# Access Compliance Report

## Public Rights-of-Way

Intersection ID: 22591	Main Street: CARMEL_RD	Cross Street: KINGSWOOD_RD	Location: SW
ADA ID: 1FB446119629	Ramp Type: PerpDiag	Initial Pass/Fail: Fail	Overall Compliance: No
		Severity Score: 12.5

#### Codes/Mitigation Info/Possible Solution

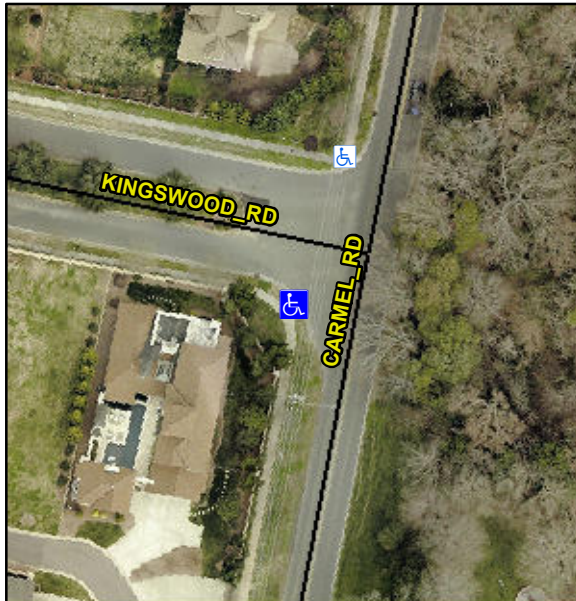
**Not Found, R304.2.2**

Compliance	Description	Data	Compliance	Description	Data
N/A	Ramp Length (in)	70.5	No	Ramp Slope (%)	10.5
Yes	Ramp Width (in)	48.0	Yes	Ramp XSlope (%)	1.8
N/A	Flare Type LT	N/A	N/A	Flare Type RT	N/A
N/A	Flare Slope LT (%)	N/A	N/A	Flare Slope RT (%)	N/A
N/A	Flare Traversable LT?	N/A	N/A	Flare Traversable RT?	N/A
N/A	Landing Length (in)	N/A	N/A	DWS Provided?	N/A
N/A	Landing Width (in)	N/A	N/A	DWS Contrast?	N/A
N/A	Landing Slope (%)	N/A	N/A	DWS Length (in)	N/A
N/A	Landing X Slope (%)	N/A	N/A	DWS Full Width?	N/A
N/A	Landing Curb? (Y/N)	N/A	N/A	DWS Offset (in)	N/A
N/A	Shared Landing?	N/A			
N/A	Gutter Ponding?	N/A	N/A	Gutter Slope (%)	N/A
N/A	Gutter Lip Ht (in)	N/A	N/A	Gutter X Slope (%)	N/A
N/A	Painted X Walk1?	No	N/A	Painted X Walk2?	No
	X Walk 1 Direction	To SE		X Walk 2 Direction	To NE
N/A	X Walk 1 Width (in)	N/A	N/A	X Walk 2 Width (in)	N/A
	X Walk 1 Slope (%)	0.0		X Walk 2 Slope (%)	3.2
	X Walk 1 X Slope (%)	3.3		X Walk 2 X Slope (%)	1.0

**Remove & Replace Curb Ramp With Two New Directional Ramps or Equivalent.**
